INITIAL FIRE SAFETY INSPECTION REPORT

M.N. Dyeing, Printing & Washing Mills Ltd

RSC ID: 24867

Date: 24th September 2023

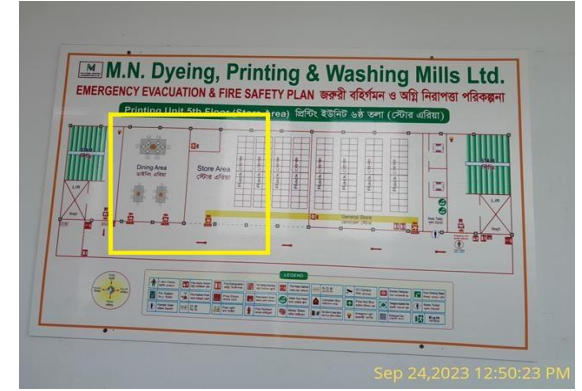
SI No.	Category	Findings	Required Action	Remediation Time Frame
F-1	Fire rated Construction	Unsealed penetrations and openings are located in the fire-rated floor/ceiling assemblies. Location: Electrical BBT riser & sewage line of 6 storied printing building.	Seal all penetrations and openings in floor/ceiling assemblies to maintain the fire separation at least by 3-hr. The used sealer shall be 3rd party certified and installation shall be as per manufacturer's datasheet. Or Provide a minimum 2-hr fire rated shaft to separate the utility risers from each floor if required.	Within 3 months
